TERREBONNE PARISH COUNCIL

AGENDA

July 23, 2018
5:35 PM

TURNING LANE, STRIPING LAYOUT & SIGNAGE PLAN

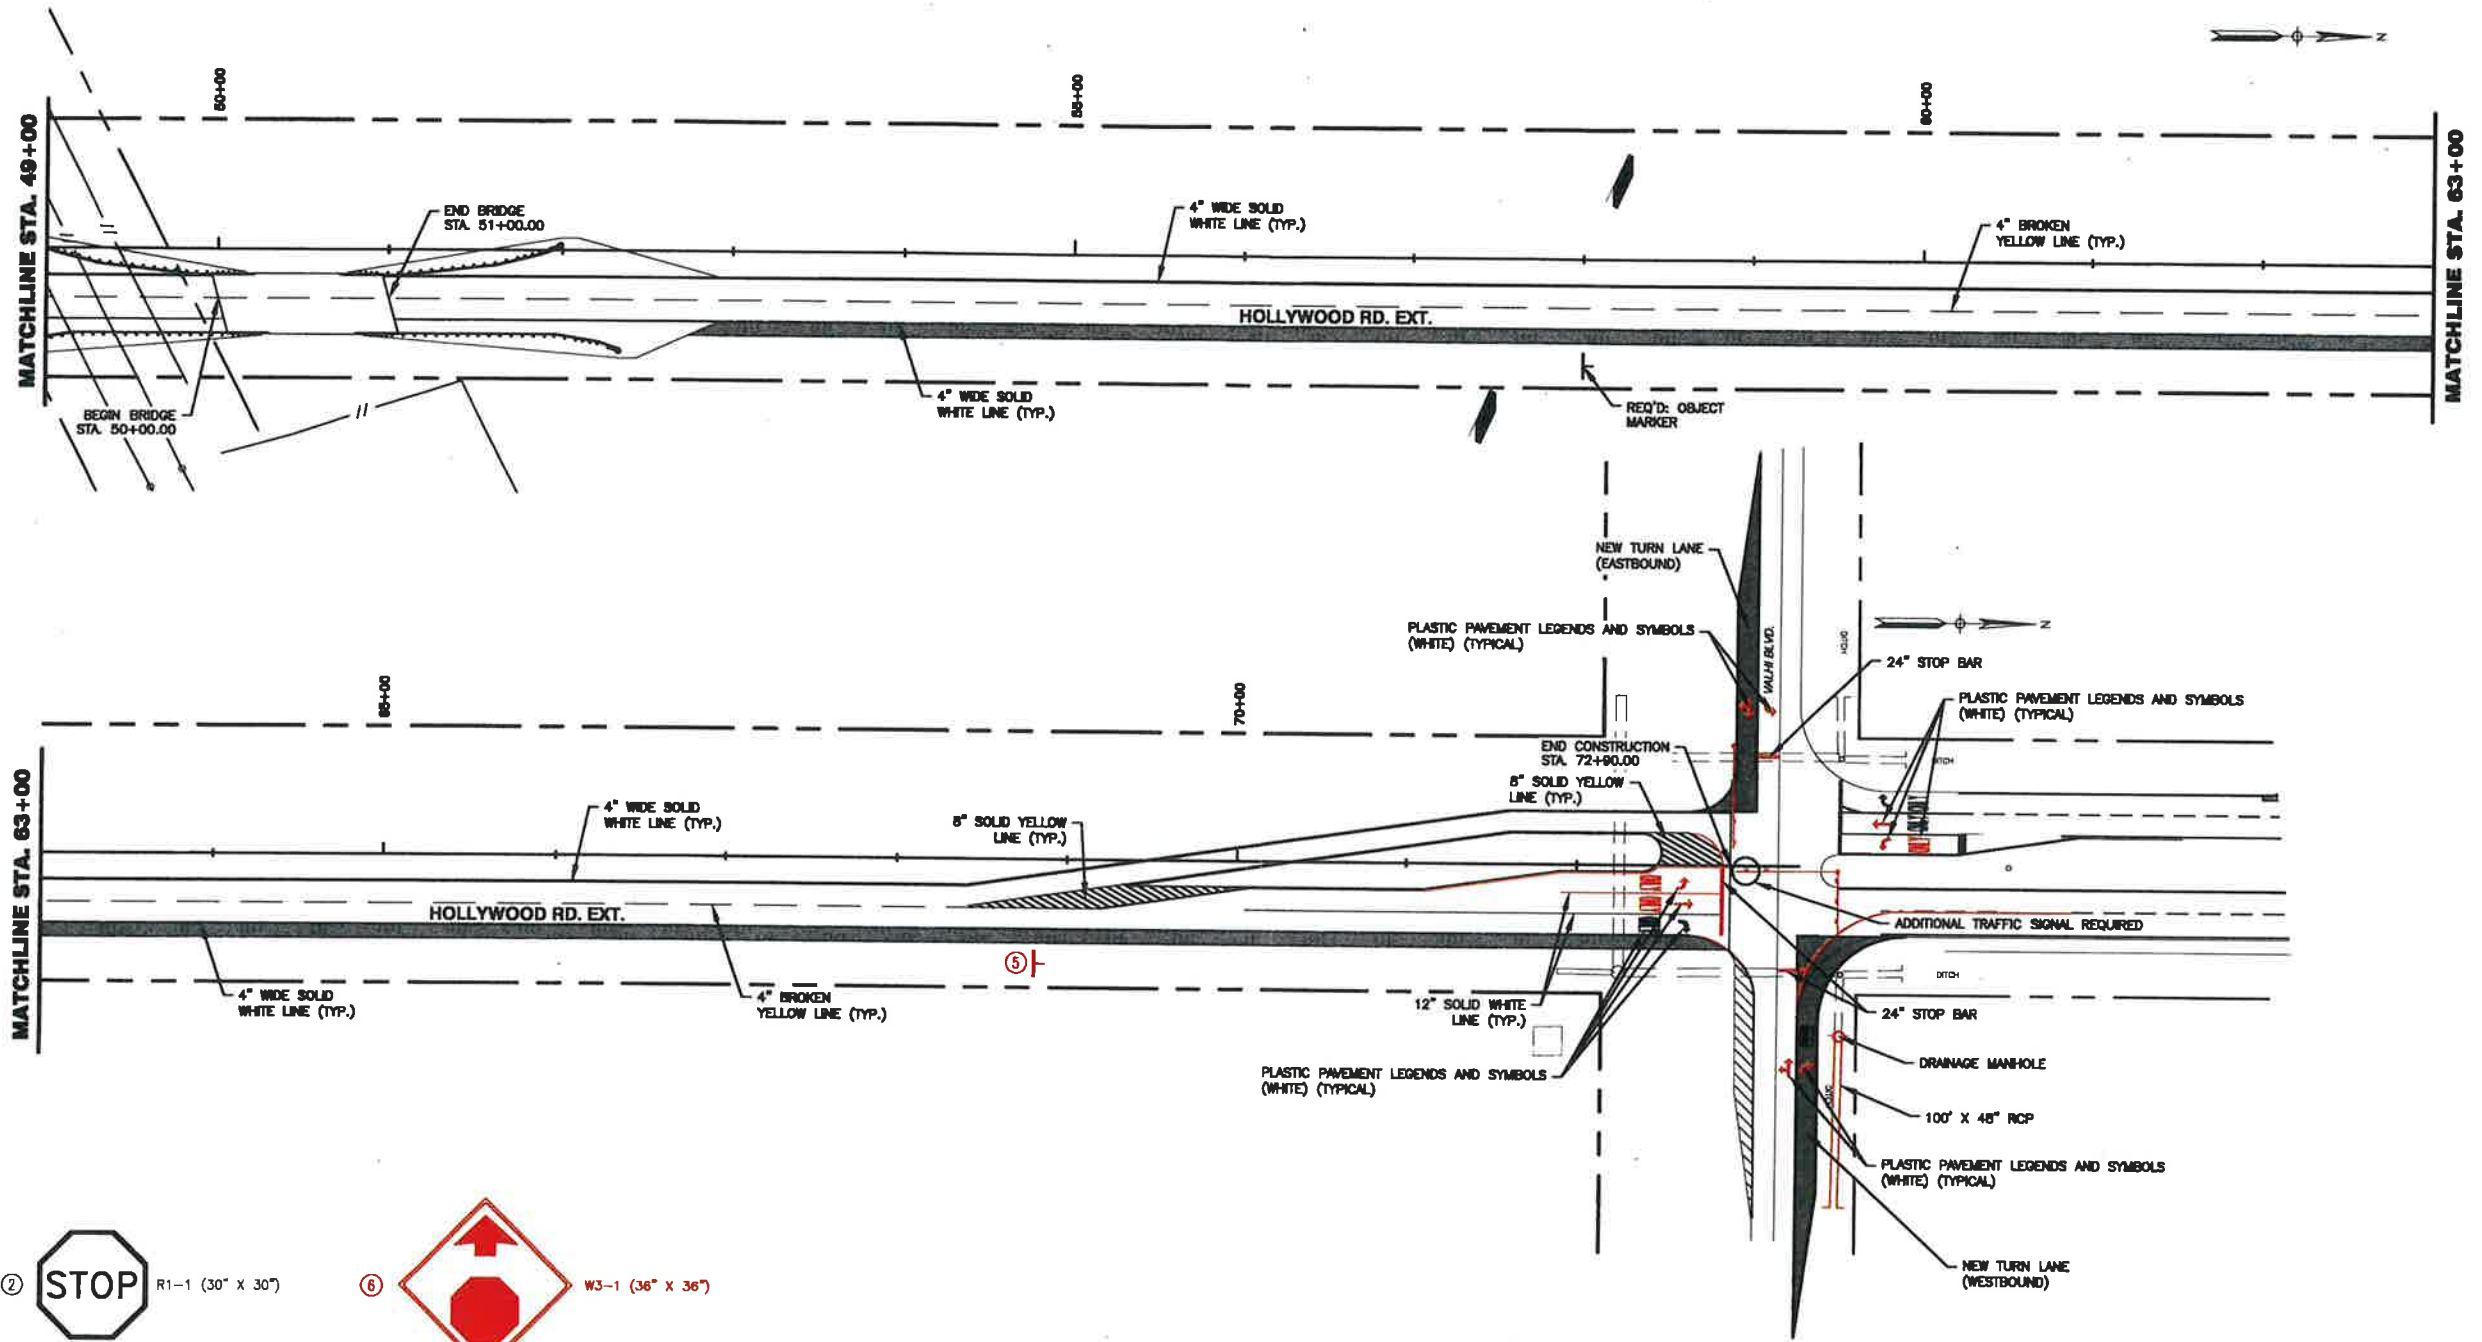
PROJECT PURPOSE & BENEFITS (150 WORDS OR LESS)
Change Order No. 4 consists of the construction of two (2) left turn lanes and the modification to the traffic lights at the intersection of Valhi Blvd. and Hollywood Road. This change order is contingent upon a budget amendment.

WHEREAS, TPCG is desirous of constructing two (2) left turn lanes and modification to the traffic lights at the intersection of Valhi Blvd. and Hollywood Road, and

203-06-a-x	Excavation and Linear Grading (Turn Lanes)	Add 0.55 Sta. @	\$1,800.00 =	\$990.00
601-01-d	Portland Cement Concrete (8")	560 S.Y. @	\$83.75 =	\$46,900.00
713-01	Temporary Signs and Barricades (Turn Lanes)	1 Ea. @	\$21,758.02 =	\$21,758.02
740-01-x	Construction Layout (Turn Lanes)	1 L.S. @	\$7,086.91 =	\$7,086.91
X-3	Modify existing signal lights to:			
	▪Single arm mast pole 60 foot length.			
	▪Dual arm mast with (1) 60 foot length arm and (1) 35 foot length arm.	1 L.S. @	\$25,765.88 =	\$25,765.88
				Total = \$154,785.81
